DESIGN INFORMATION ARCHITECTS	TRUE NORTH:	PROJECT STATUS: ISSUED FOR \$4.56 RE-SUBMISSION	PREPARED FOR: JOE NEHME	PROJECT ADDRESS: 73 LACHLAN STREET WARWICK FARM 2170 LOTS 1 & 2 IN DP 105859	SHEET NO: S 002	TITLE: SITE PLAN	GENERAL NOTES 1. ALL WORKS TO BE IN ACCORDANCE WITH THE BUILDING CODE OF AUSTRALIA. 2. PART C1 - FIRE RESISTING CONSTRUCTION 3. STATUTORY REGULATIONS AND LOCAL AUTHORITY REQUIREMENTS, INCLUDING CONDITIONS OF 4. CONSENT 5. DO NOT SCALE OFF THIS DRAWING. ONLY DIMENSIONS PROVIDED 6. CONTRACTOR TO VERIFY ALL DIMENSIONS ON SITE PRIOR TO COMMENCING WORK 7. DESIGN FORMATION DRAWINGS TO BE READ IN CONJUNCTION WITH ALL CONTRACT DOCUMENTS FROM ALL CONSULTANTS 8. CONTRACTOR TO NOTIFY DESIGN FORMATION OF ANY DISCREPANCIES, DIMENSIONAL INCONSISTENCIES, OR THE NEED FOR CLARIFICATION PRIOR TO MANUFACTURING. 9. CONTRACTOR TO ENSURE COORDINATION BETWEEN MATERIALS IS MAINTAINED 7. DESIGN FORMATION TO REVIEW ALL CONTRACTORS DETAILED DRAWINGS / SETTING OUT PRIOR TO CONSTRUCTION 8. PROGRESS WORK TO BE VERIFIED AGAINST DRAWINGS FOLLOWING EXECUTION AND ARCHITECT TO BE NOTIFIED OF ANY DISCREPANCIES PRIOR TO CONTRACTOR PROCEEDING WITH NEXT TRADE	ALL CONSTRUCTION TO COMPLY AT MINIMUM WIT

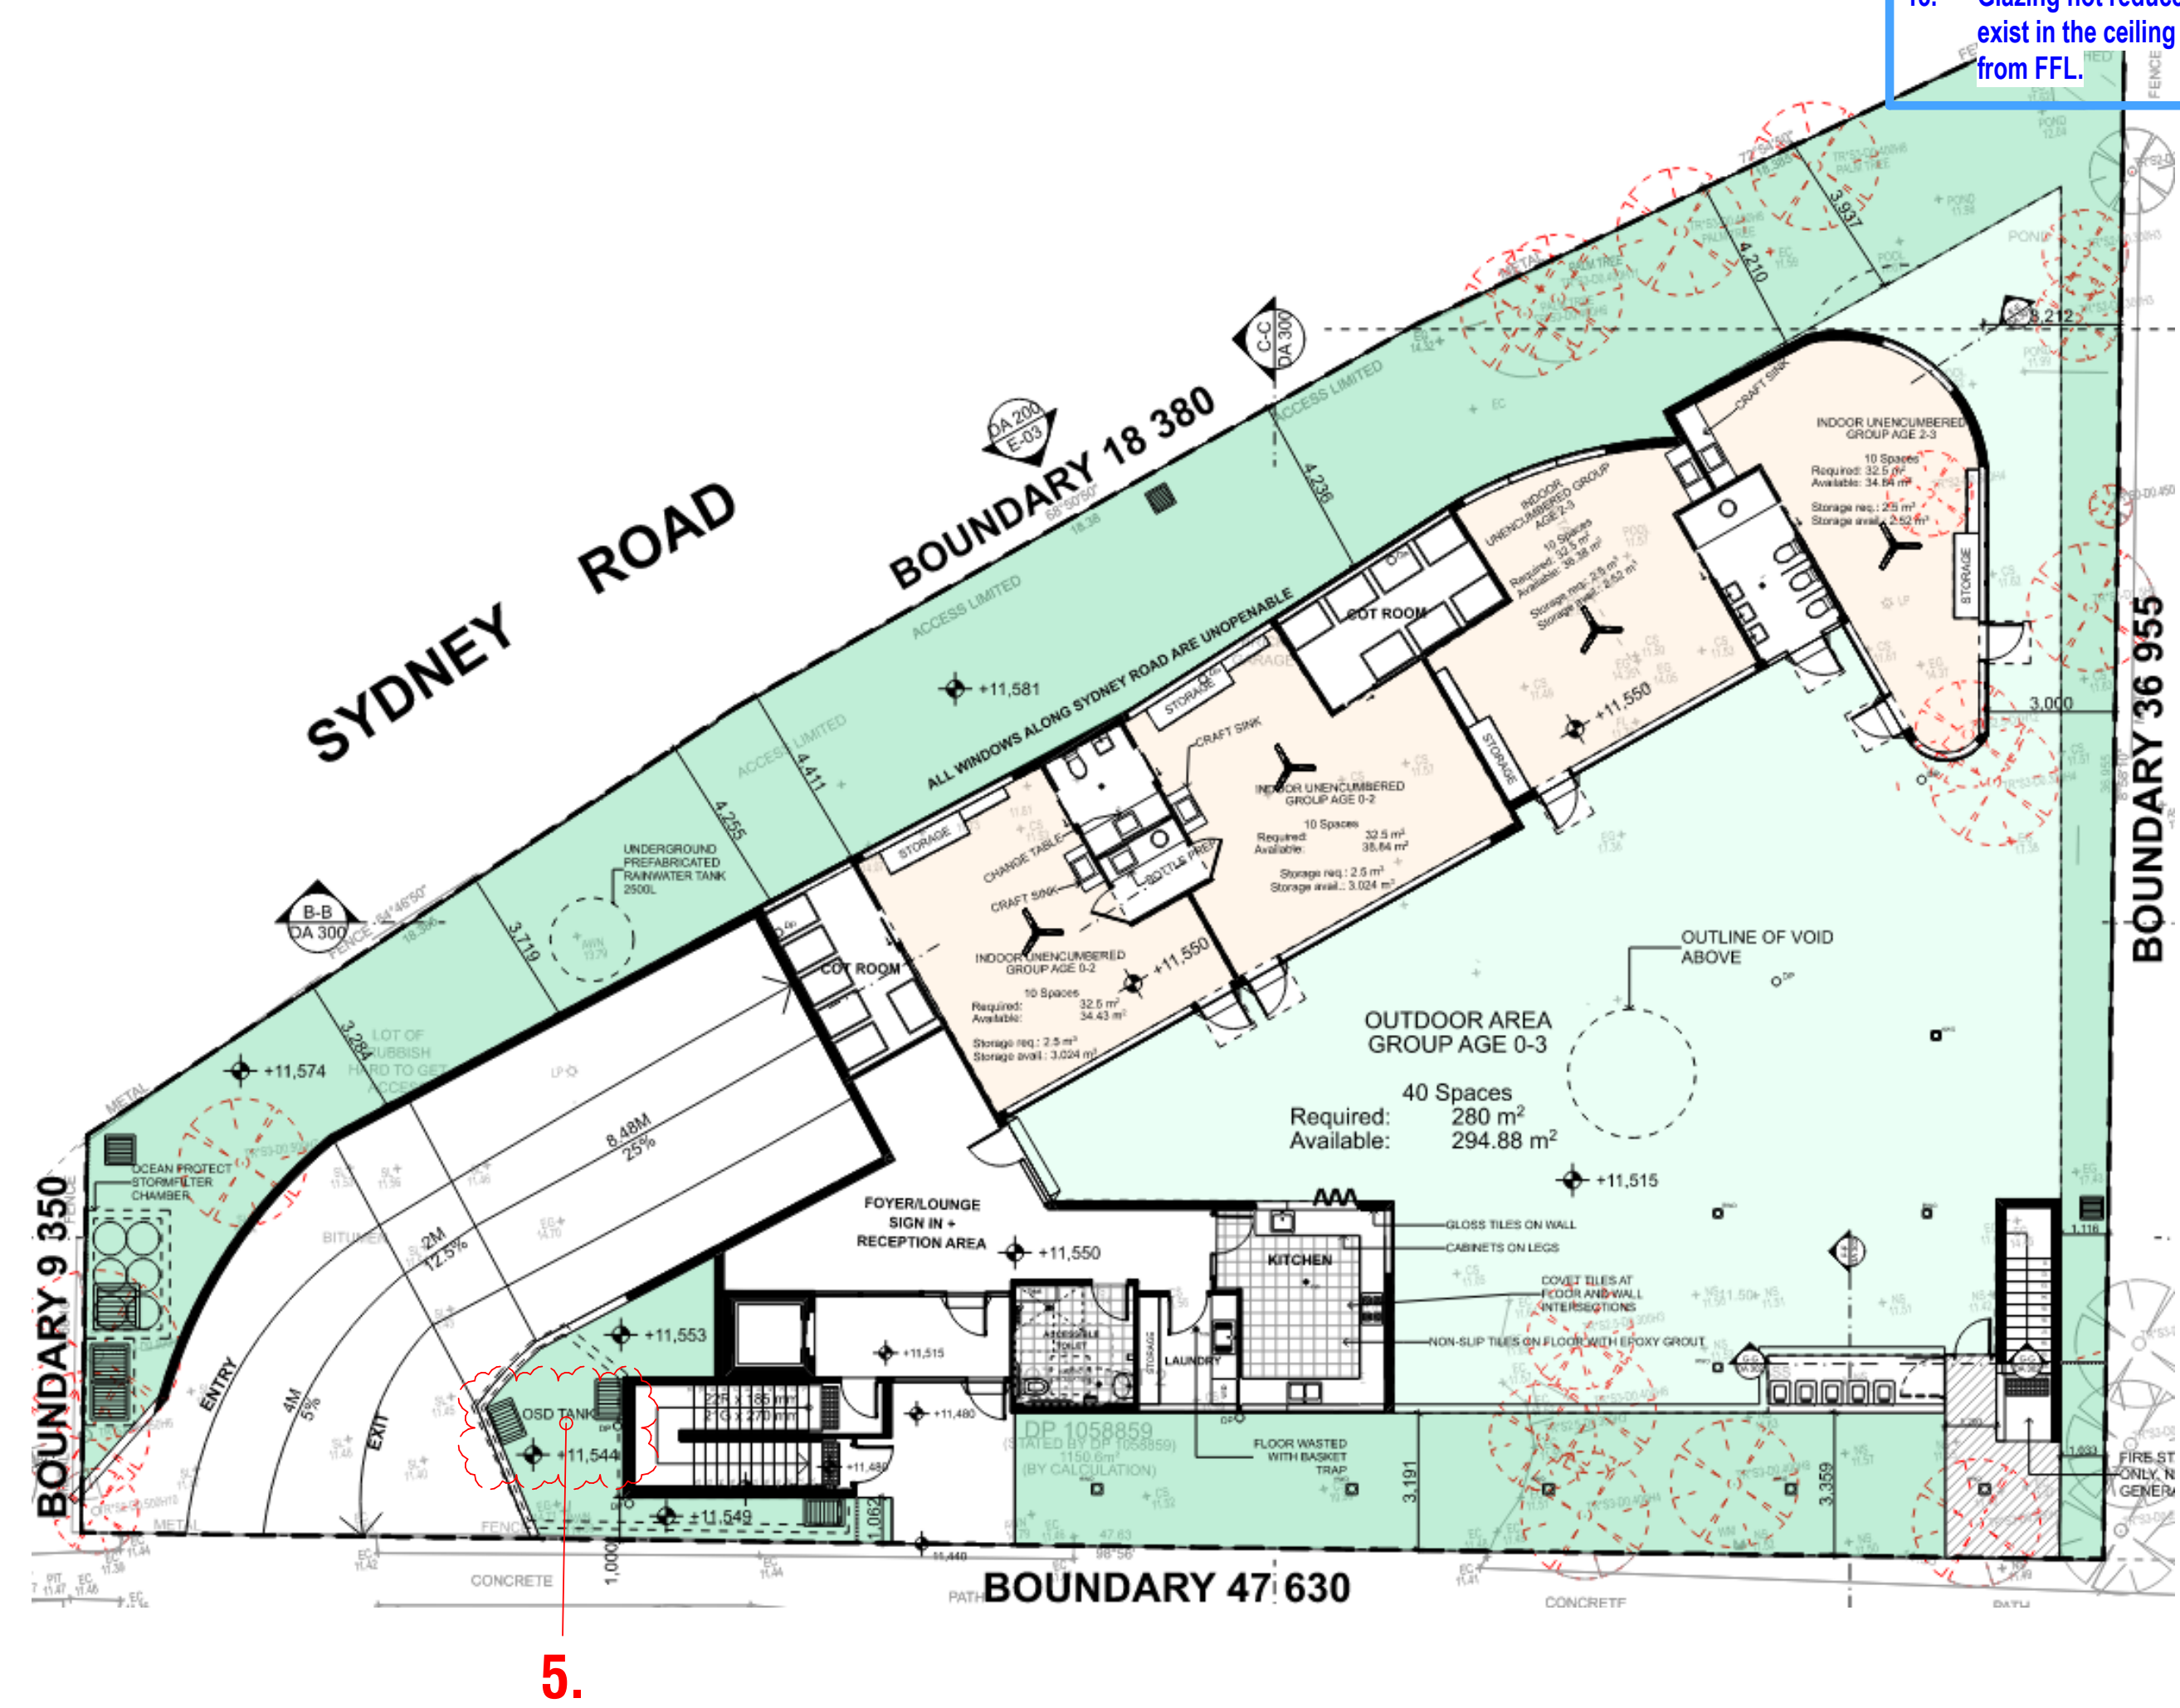
1. Car Parking Level amended to reduce Structural spans and added provisions.
2. Passenger Lift size increased to allow for compliant Accessible Car size. Lift Shop Drawings coordinated.

3. Building Services and Structure integrated i.e. Pump Room(s), Meter Cupboard(s), Switch/Comms Room, Mechanical Ducts added.
4. Shoring design integrated; Dry Walls added to Fire Exits and Plant Rooms for Waterproofing requirements.

5. O.S.D. Tank relocated due to Fire Pump Room non-compliance and basement headroom clearance issues.
6. Fire Sprinkler Pump Room and Booster Assemblies added as required and in accordance with NSW Fire Brigade requirements.

7. Fire Exit gate added to Sydney Road boundary as required by Fire Egress requirements.
8. Non-fire isolated Egress Stair added to building as required.

9. Fire Isolated Stairs amended to comply with BCA requirements and Mechanical / Fire Hydrant provisions added
10. Staff Room altered from Level 03; Storage added.

11. Building Element formed in Concrete (previously steel roof framing).
12. Level 03 Slab Outline adjusted to align with the building under.
13. Stacked Stone Tile Finish replaced with Cladding. Facebrick added partially to Ground Floor Level.

14. Planterbox added to allow Landscaping over Basement.
15. All Glazing reduced to 2500mm head height and Window Sills 1050mm above FFL.
16. Horizontal Exits added for Fire Compartments - Openings removed where required.

1. Fire Stair shifted to comply with 900mm min. side setback.
2. Landscaping Calculation Diagrams added.
3. Staff Room reinstated at Level 03.
4. Lift Lobby / Foyer areas increased to improve circulation; Basement Level 01 Lift Lobby area secured from parking manoeuvring.

5. OSD relocated out of Deep Soil Zone to under the driveway.
6. Building Services along Lachlan Street have been reduced to increase the Landscape Area along the Street Frontage; Bins rotated to avoid visibility from Street; Fire Egress from Basement reduced in built form to assist.

7. Additional Fire Egress Stair shifted to be integrated into the approved built form and articulation; Material changes and Glazing added to improve the facade along Sydney Road; Windows to Play Rooms increased along Northern facade accordingly.

8. Fire Egress from Basement reduced in built form as recommended.
9. Awning Edge Detail provided showing Cladding fixed to Slab Edge demonstrating a good design outcome.

10. Outline of Level 03 Slab Profile added to show where it has been reduced and extended to ONLY align with Approved Building Envelope below and ease of construction.

12. Planterbox added to allow the landscaping to be retained over the basement - Landscape Drawings maintain medium height trees to be planted in this area.

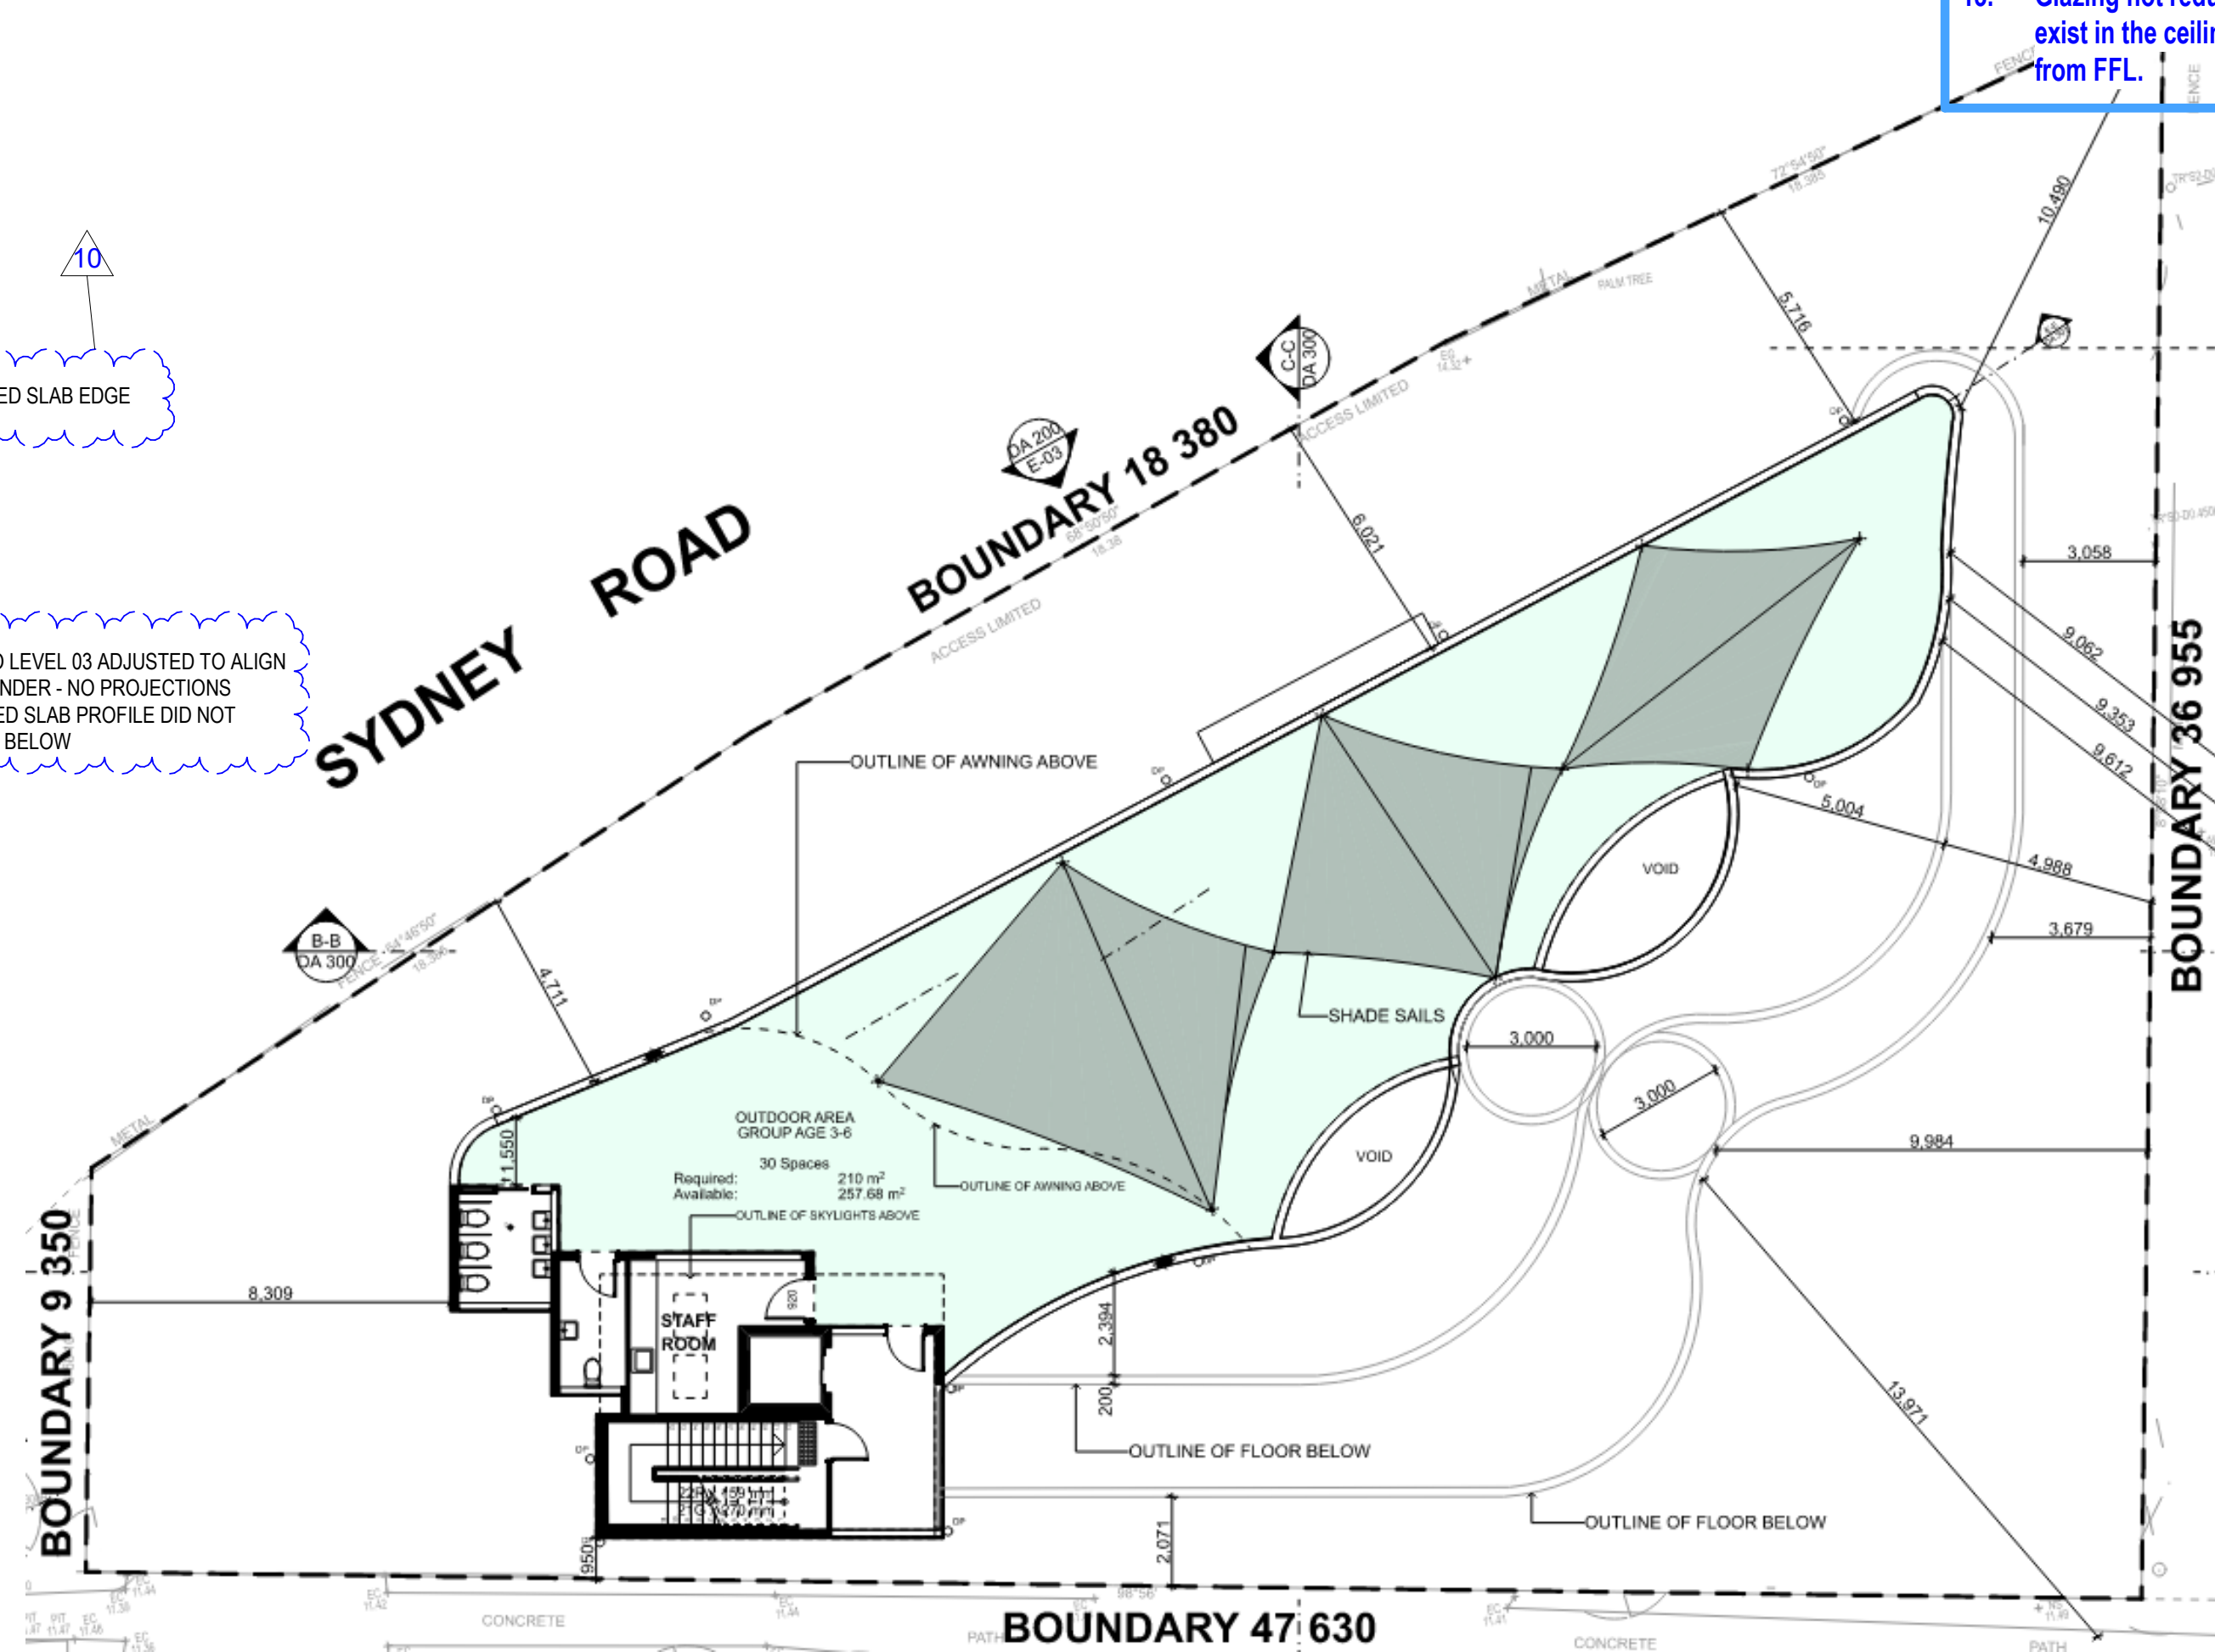
1. Car Parking Level amended to reduce Structural spans and added provisions.
2. Passenger Lift size increased to allow for compliant Accessible Car size. Lift Shop Drawings coordinated.

3. Building Services and Structure integrated i.e. Pump Room(s), Meter Cupboard(s), Switch/Comms Room, Mechanical Ducts added.
4. Shoring design integrated; Dry Walls added to Fire Exits and Plant Rooms for Waterproofing requirements.

5. O.S.D. Tank relocated due to Fire Pump Room non-compliance and basement headroom clearance issues.
6. Fire Sprinkler Pump Room and Booster Assemblies added as required and in accordance with NSW Fire Brigade requirements.

7. Fire Exit gate added to Sydney Road boundary as required by Fire Egress requirements.
8. Non-fire isolated Egress Stair added to building as required.

9. Fire Isolated Stairs amended to comply with BCA requirements and Mechanical / Fire Hydrant provisions added
10. Staff Room altered from Level 03; Storage added.

11. Building Element formed in Concrete (previously steel roof framing).
12. Level 03 Slab Outline adjusted to align with the building under.
13. Stacked Stone Tile Finish replaced with Cladding. Facebrick added partially to Ground Floor Level.

14. Planterbox added to allow Landscaping over Basement.
15. All Glazing reduced to 2500mm head height and Window Sills 1050mm above FFL.
16. Horizontal Exits added for Fire Compartments - Openings removed where required.

1. Fire Stair shifted to comply with 900mm min. side setback.
2. Landscaping Calculation Diagrams added.
3. Staff Room reinstated at Level 03.
4. Lift Lobby / Foyer areas increased to improve circulation;
Basement Level 01 Lift Lobby area secured from parking manoeuvring.

5. OSD relocated out of Deep Soil Zone to under the driveway.
6. Building Services along Lachlan Street have been reduced to increase the Landscape Area along the Street Frontage; Bins rotated to avoid visibility from Street; Fire Egress from Basement reduced in built form to assist.

7. Additional Fire Egress Stair shifted to be integrated into the approved built form and articulation; Material changes and Glazing added to improve the facade along Sydney Road; Windows to Play Rooms increased along Northern facade accordingly.

8. Fire Egress from Basement reduced in built form as recommended.
9. Awning Edge Detail provided showing Cladding fixed to Slab Edge demonstrating a good design outcome.

10. Outline of Level 03 Slab Profile added to show where it has been reduced and extended to ONLY align with Approved Building Envelope below and ease of construction.

12. Planterbox added to allow the landscaping to be retained over the basement - Landscape Drawings maintain medium height trees to be planted in this area.
